NOTES FROM SEA

MARINE ENGINEERING

Comments by D.M.E.

FIG. 1—TWO IN NO. ARE REQUIRED : 1 IN NO. WITH ¼ IN. HOLE AND AIR OR WATER HOSE ; 1 IN NO. BLANK

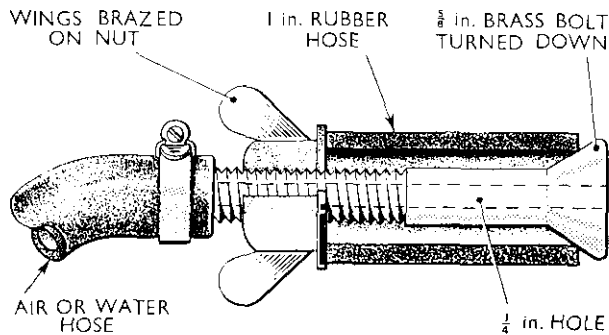
On opening the starboard boiler for water washing, water was seen fountaining from the superheater near the top of the tube end bends, between the support and the monolithic wall.

Identification of the burst tube proved impossible until a small fitting was devised for testing each tube individually. The device, which is self explanatory, is shown in FIG. 1.

In *Blackwood, Whitby* and similar classes with very compact superheaters it may indeed be difficult to locate a leaking tube and this device would appear to be an excellently simple and effective means of doing so. It is recommended to other ships of the same or similar classes.
